Griffith Avenue – Phase 1 Protected Cycle Lanes

Stage 3 Road Safety Audit

October 2020

Figure 2.4 – RSA Collisions Records (2005-2016) in vicinity of the proposed scheme (www.RSA.ie)

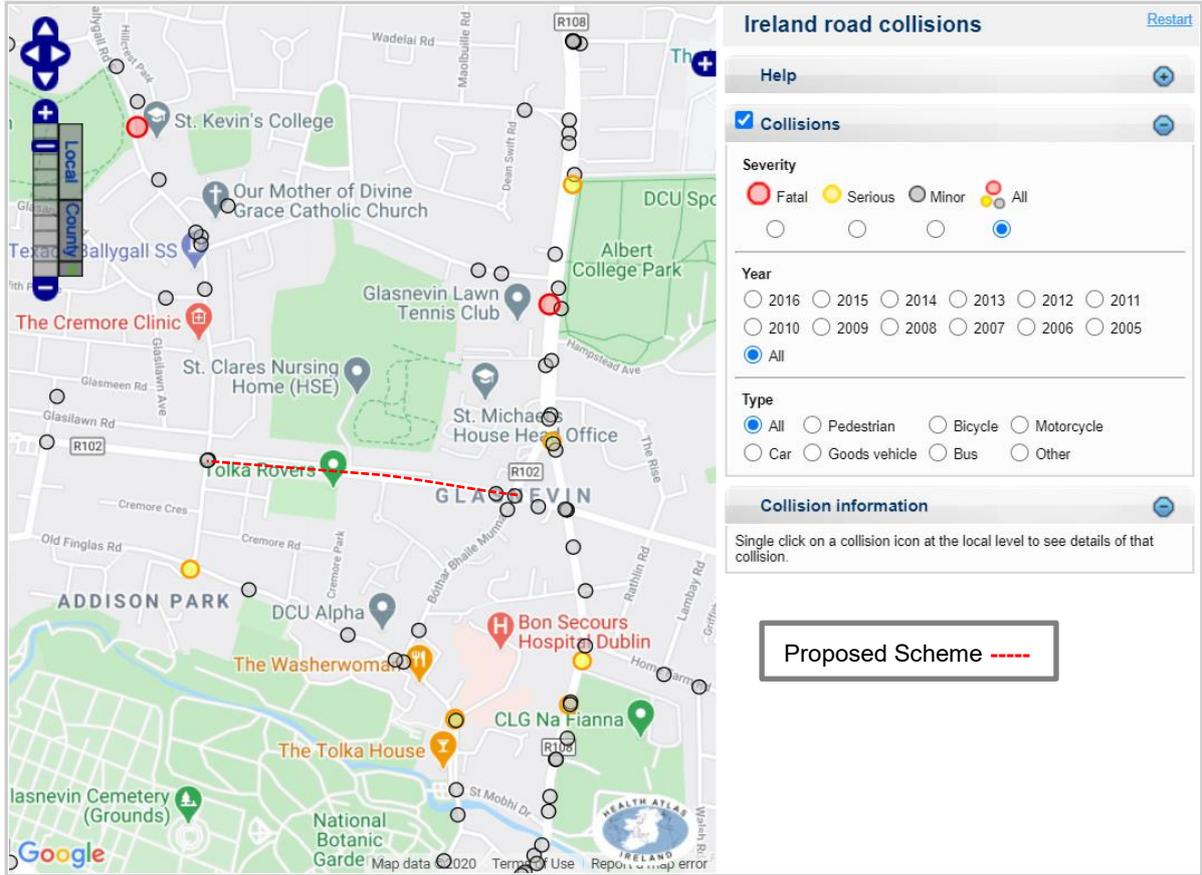
- The RSA database of road collisions was examined to establish if there are any existing safety issues within the site that were not evident from the site visit.
- The database provides collision records for the period 2005 to 2016, with Figure 2.4 below outlining the recorded collisions over the 12 year period.
- 3 collisions occurred on the Griffith Avenue along the proposed scheme, of which all were minor and occurred at the junctions at either ends of the scheme. One collision involved a motorcycle with the other two involving cars.

Figure 4.4 – Example of Leaves Along the Cycle Lane

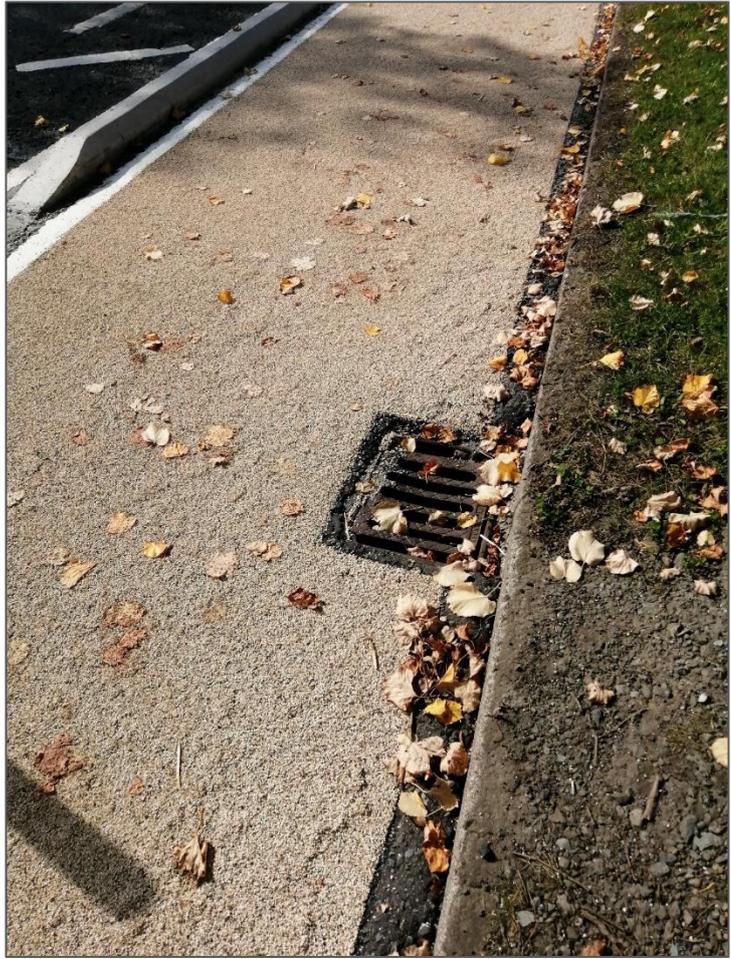
4.5.2 Problem	
<i>Location:</i>	Throughout the scheme
<i>Drawing:</i>	NA
<i>Summary:</i>	Maintenance of the cycle lanes

Due to trees being provided along both sides of the carriageway adjacent to the cycle lane, there is a risk that should regular maintenance not be undertaken that this would lead to a build-up of debris in the cycle lane. This would result in the cycle lane becoming slick with leaves and may lead to cyclists losing grip and falling off their bike.

An appropriate maintenance strategy should be developed to keep the cycle lane clear of tree foliage and debris.
